SUBJECT: Preliminary Subdivision Plan Re-Approval for the single-family residential
Open Space Conservation Subdivision and Final Plat and Site Improvement
Plans for Reserve at River Oaks Phase III

PC Case No: 2018-2628

Re: **The Reserve at River Oaks Phase 3 Plan & Plat Review**

THE RESERVE AT RIVER OAKS EXPANDED PRELIMINARY PLAN RE-APPROVAL

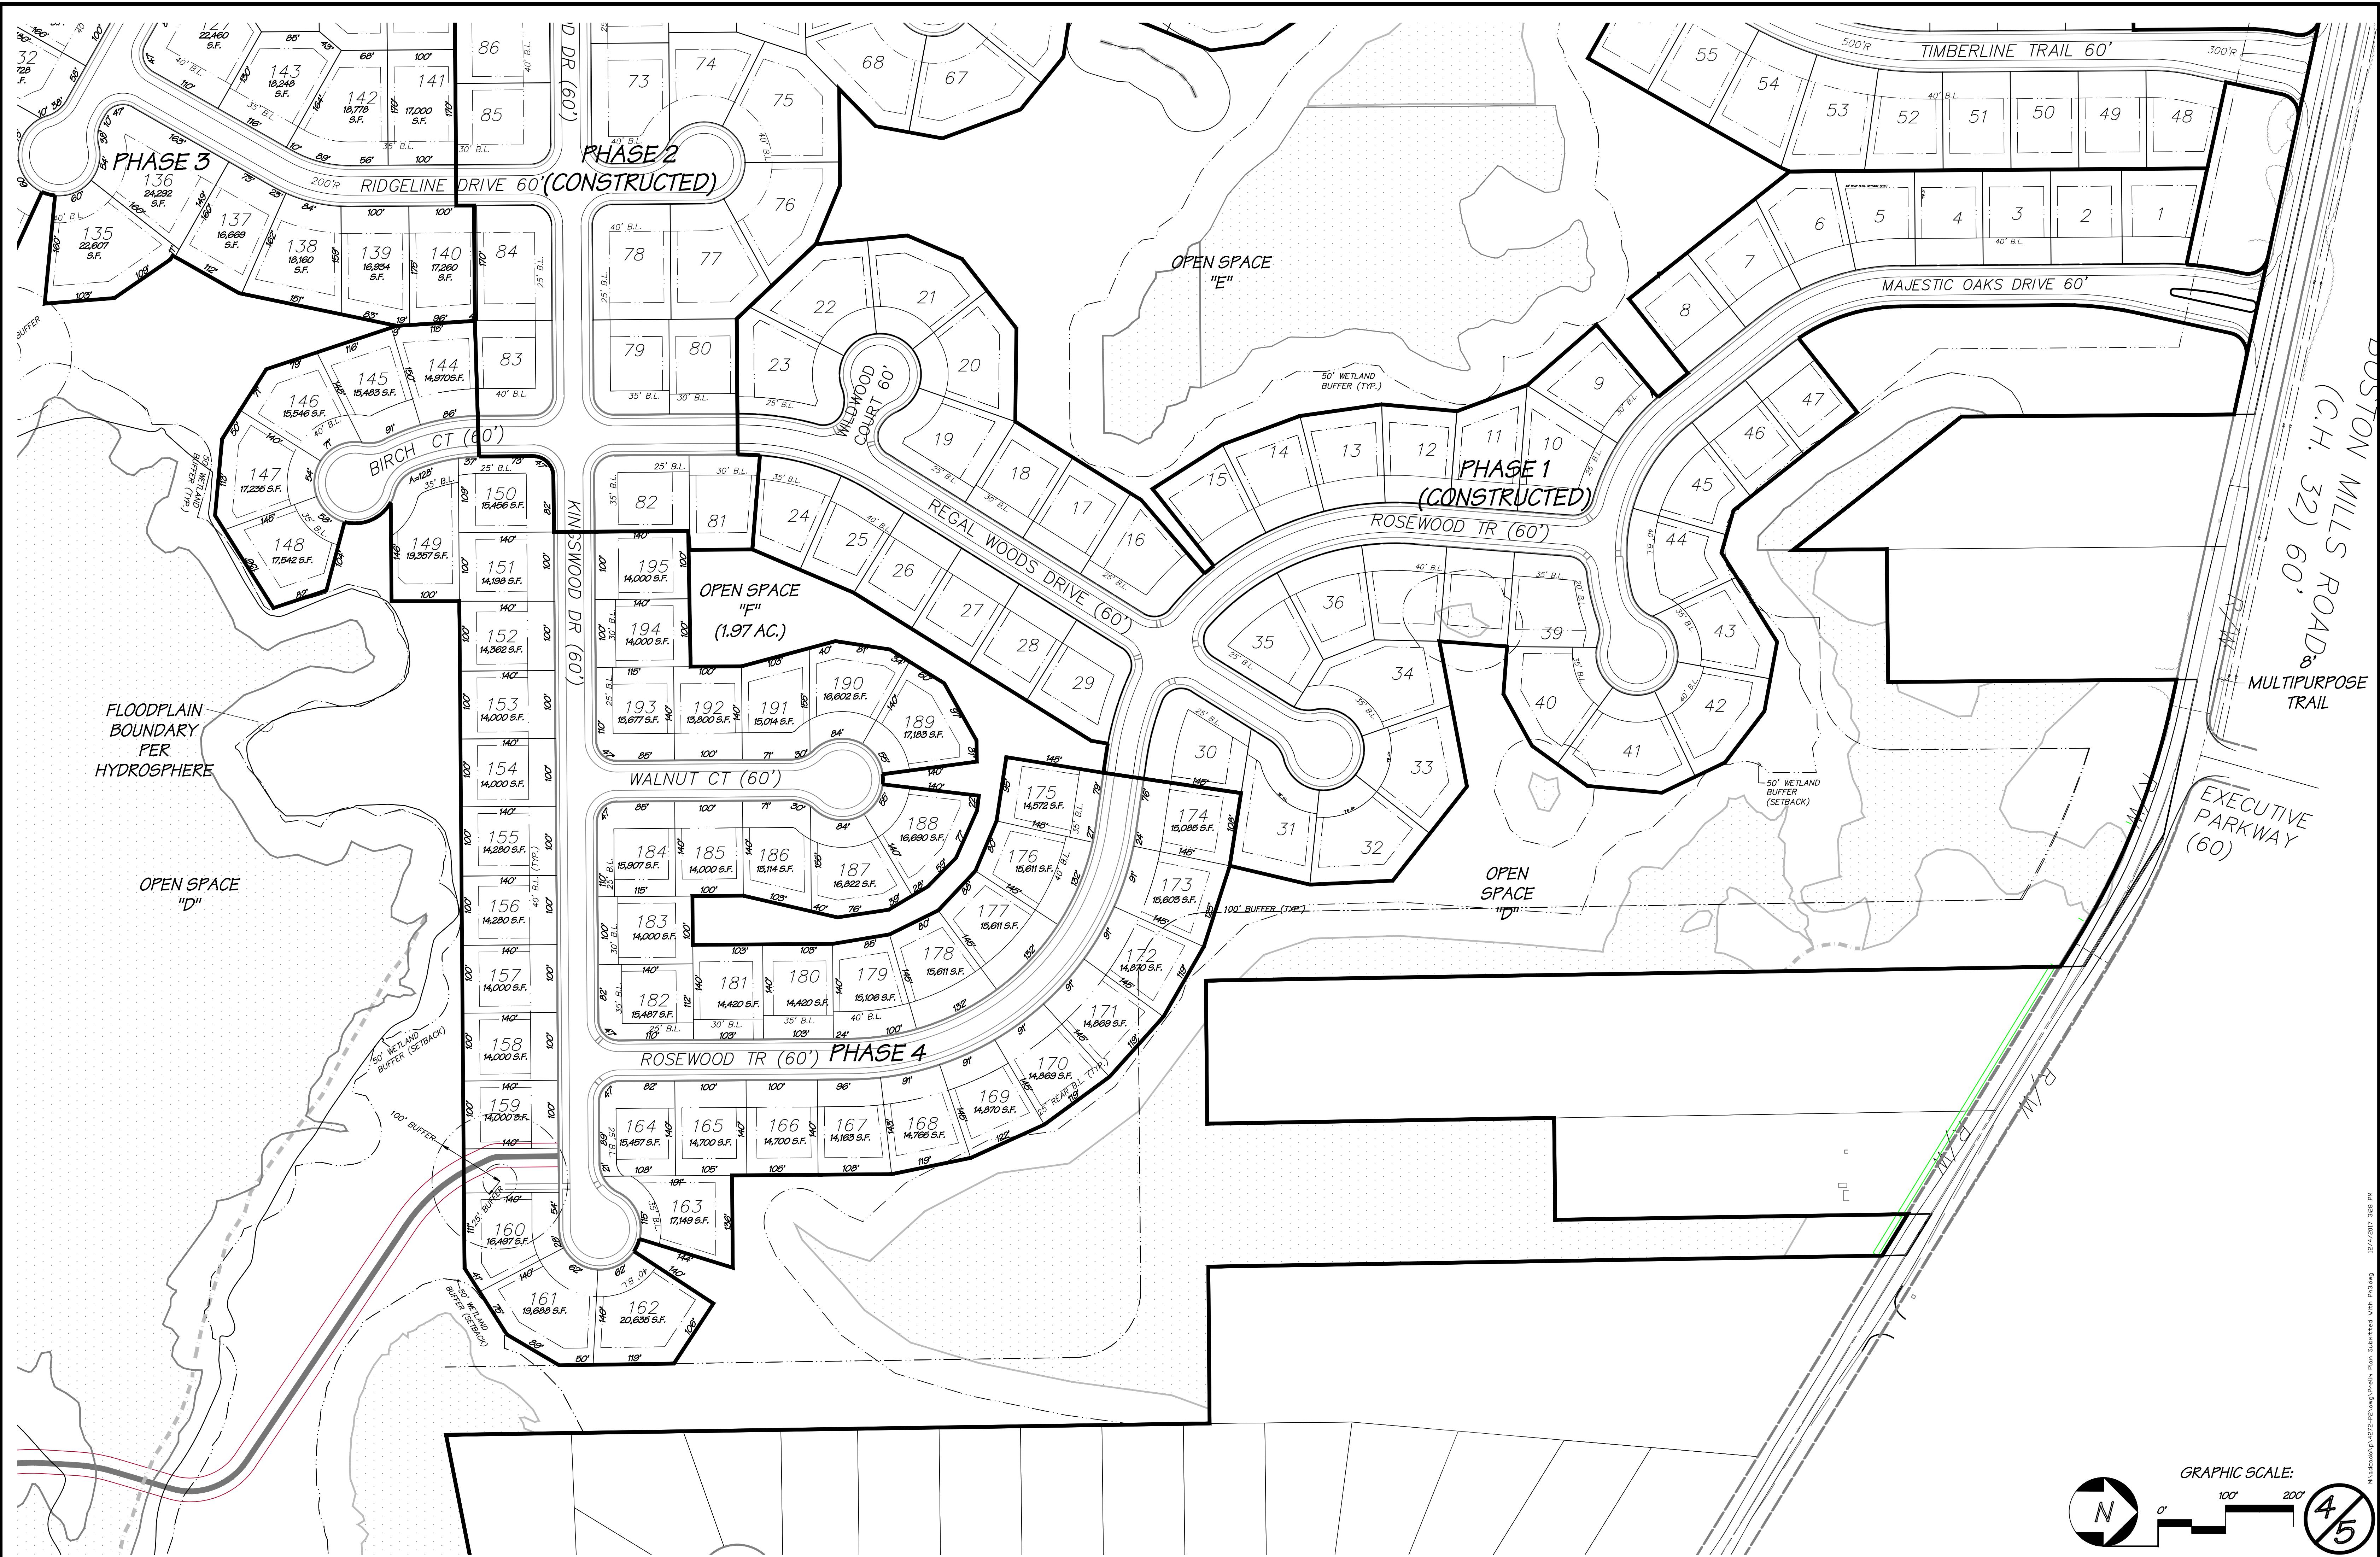
As part of the application for Phase III Final Plat, the applicant must seek to renew the preliminary plan approval as more than a year has passed since the recording of the Phase II final plat. Staff notes the proposed subdivision boundary, number of sublots, pedestrian connections, and clearing limits have not changed since the previous plan approval. Additionally, no amendments have been made to the LDC which would impact the proposed development.

Approve the application for Case No. 2018-2628 for Preliminary Subdivision Plan Re-Approval for the single-family residential Open Space Conservation Subdivision known as the Reserve at River Oaks, Phases 1-5 according to plans dated as received December 8, 2017.

GRADING PLAN

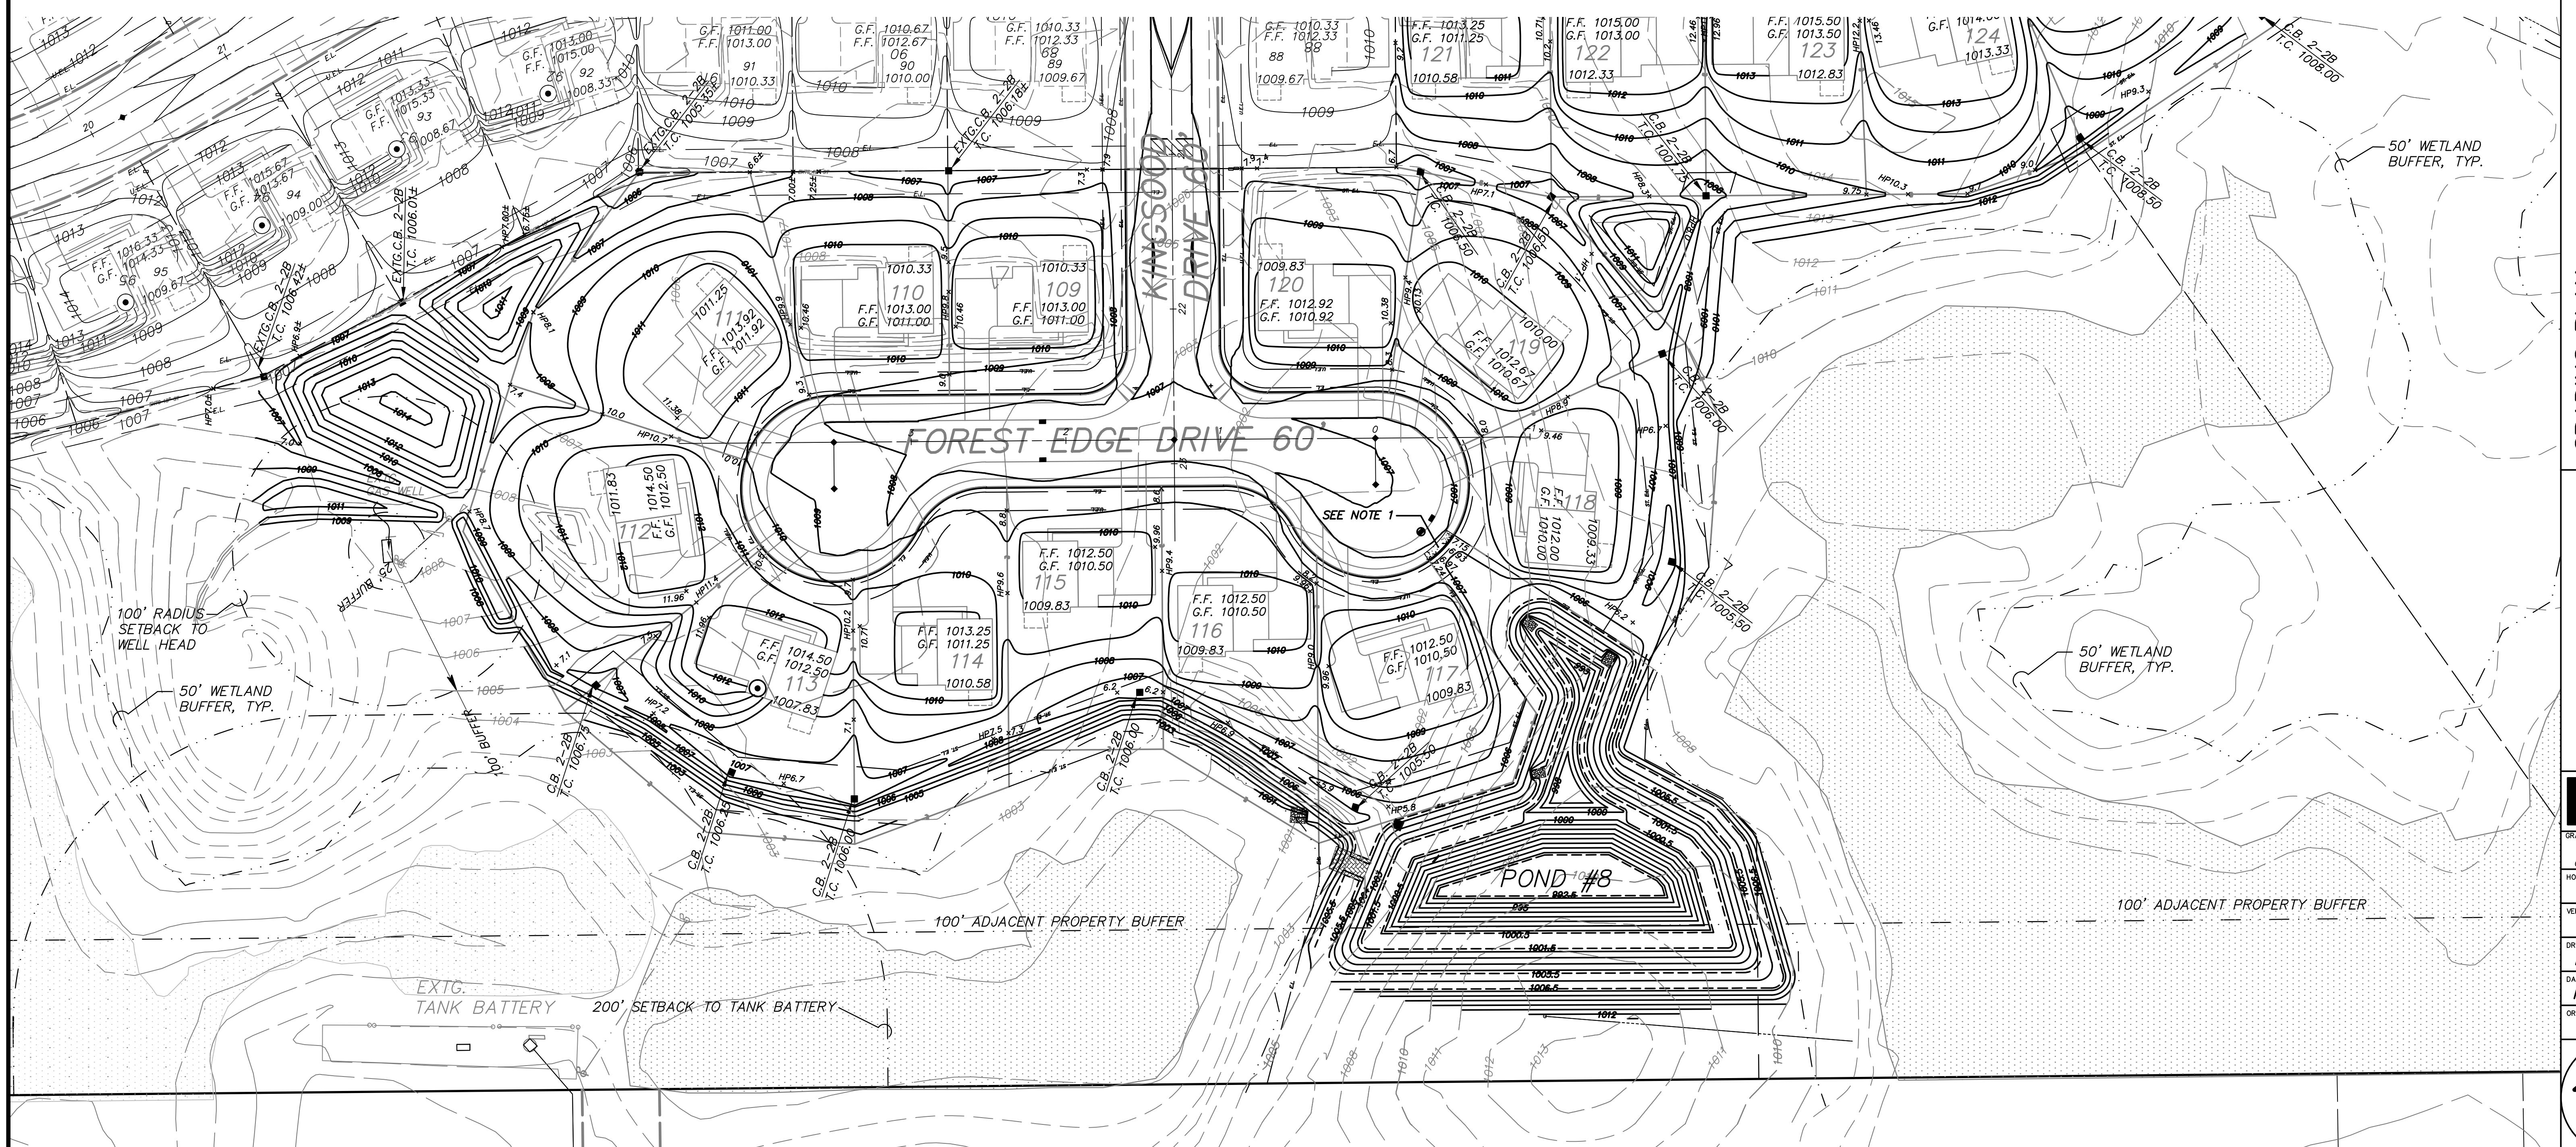
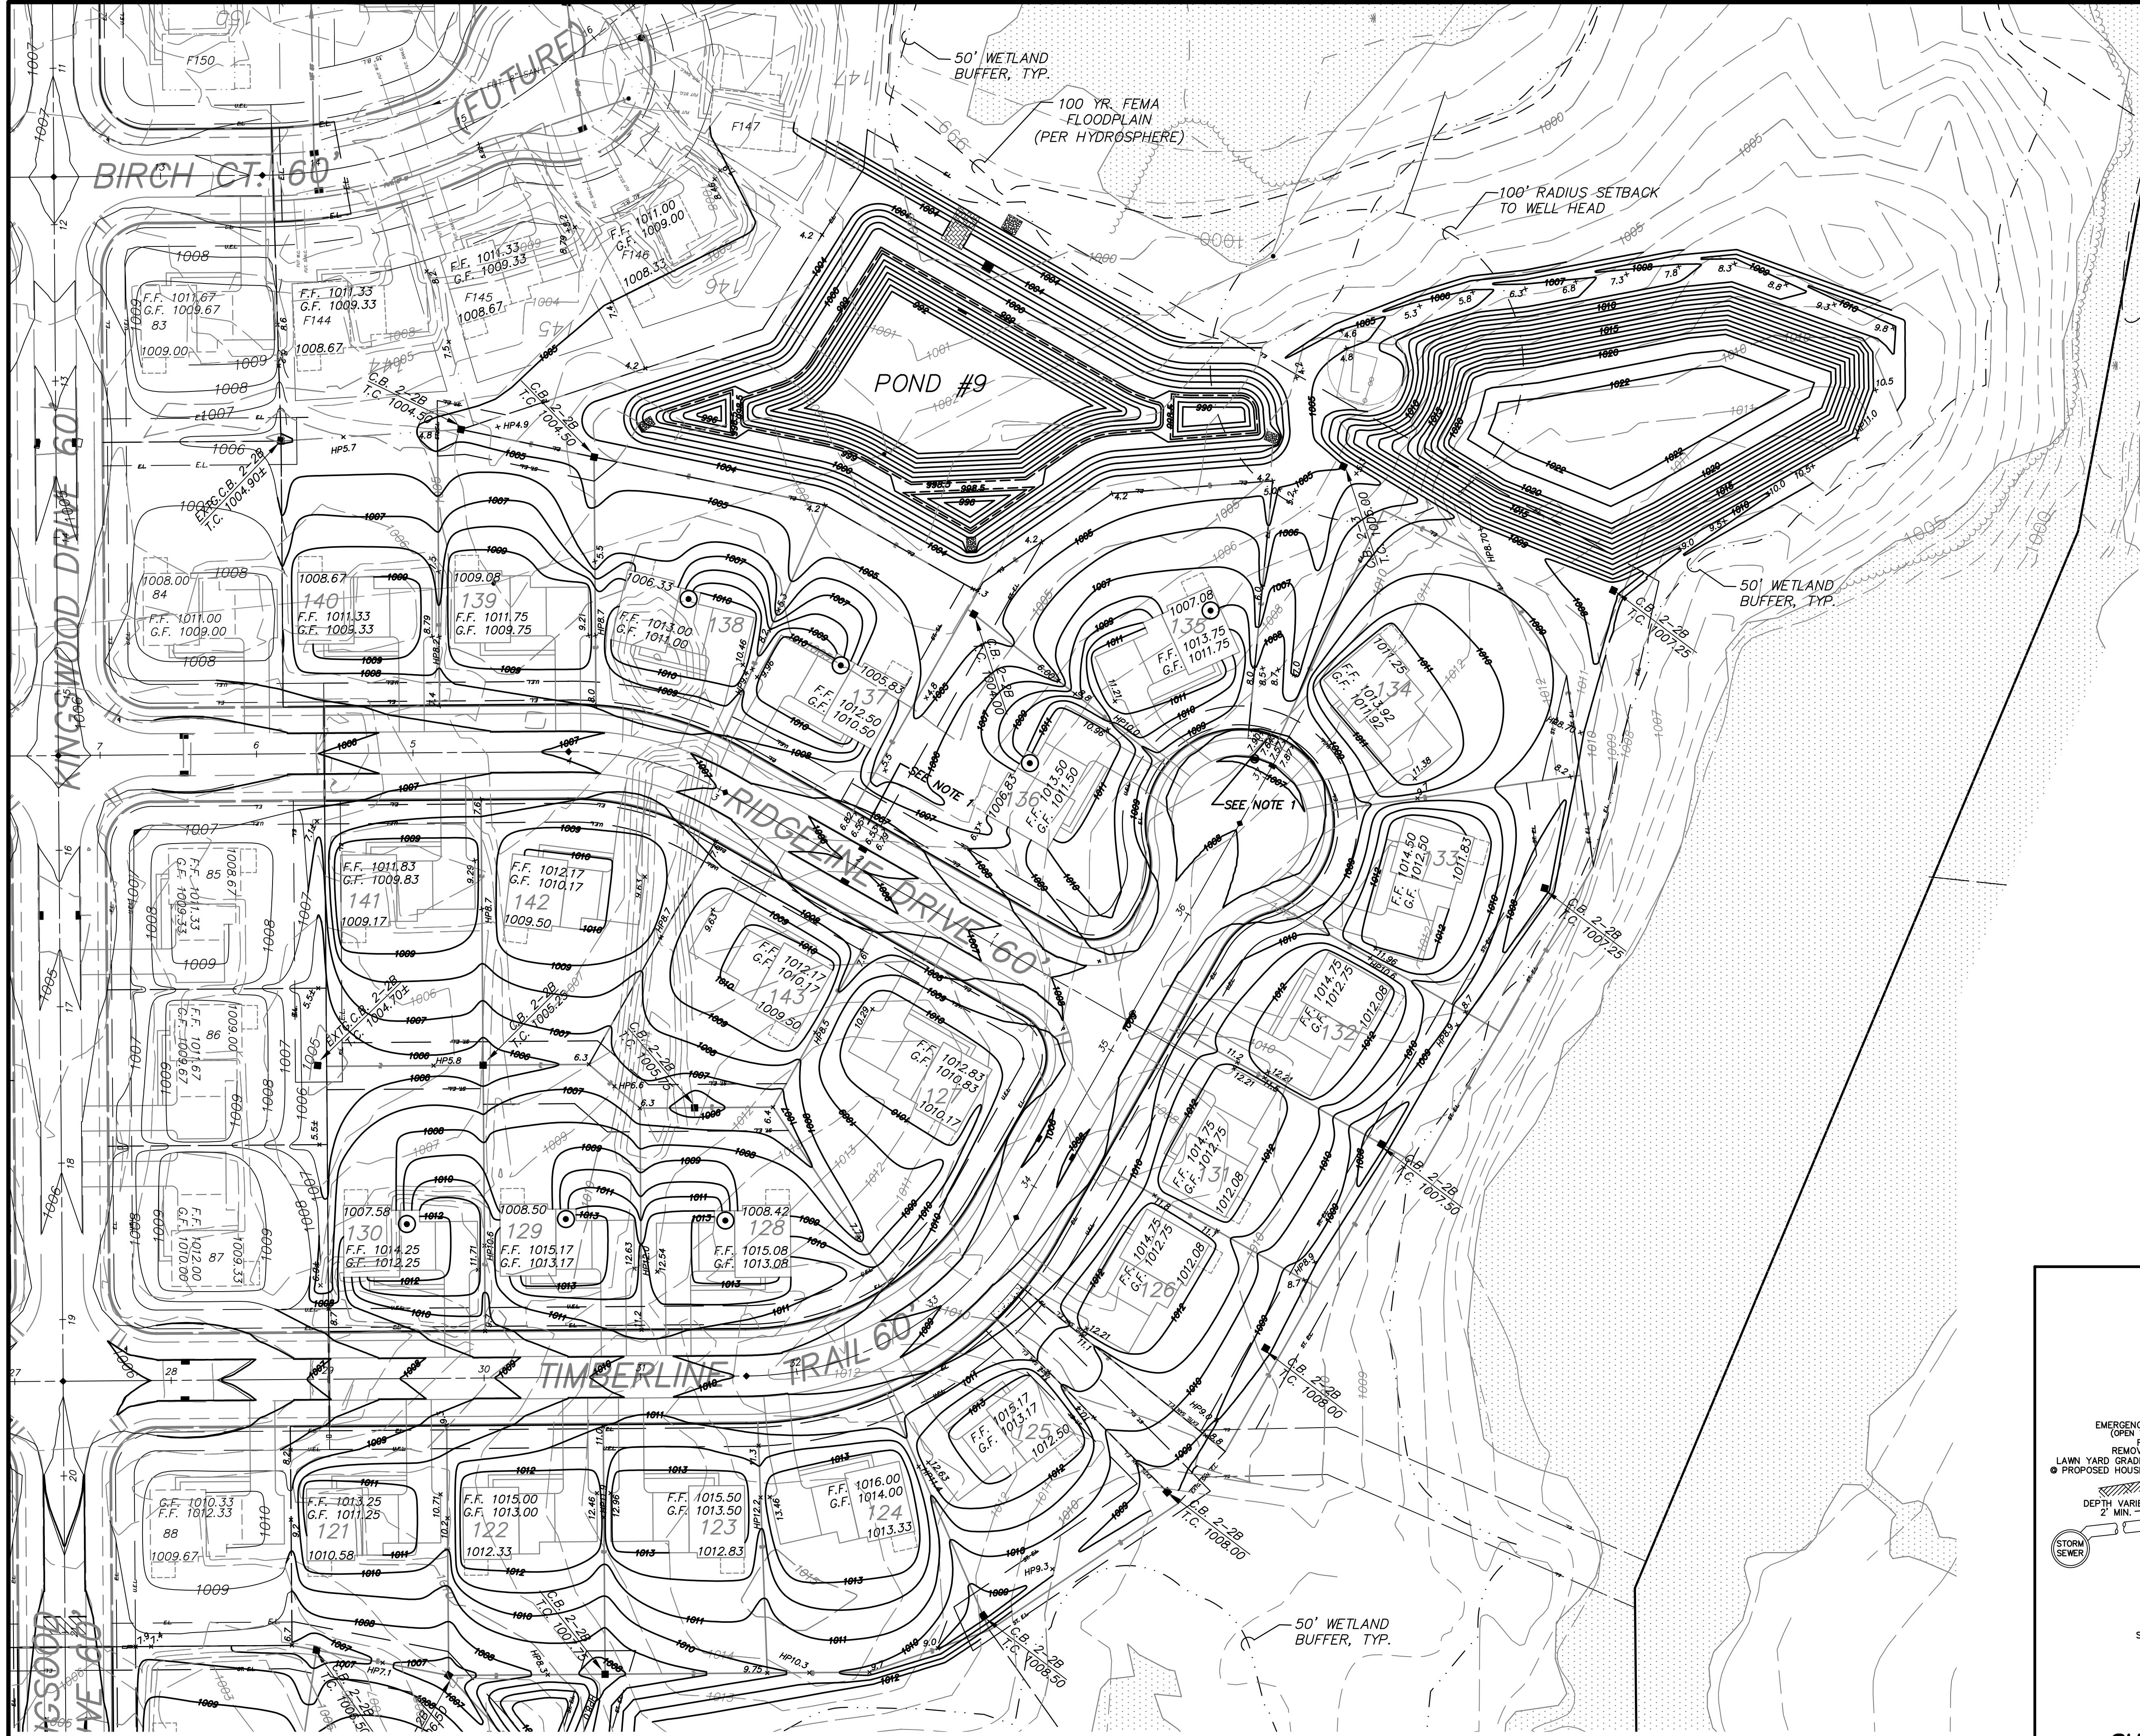
1. Call out 100-year, major, flood paths and label (same as previous submittals) per City of Hudson Engineering Standards, Section 5.2.
2. Verify that basement floor elevations are above the proposed storm water management pond's 100-year elevations.
3. Provide cross sections for 100-year, major, flood path (same as previous submittals)
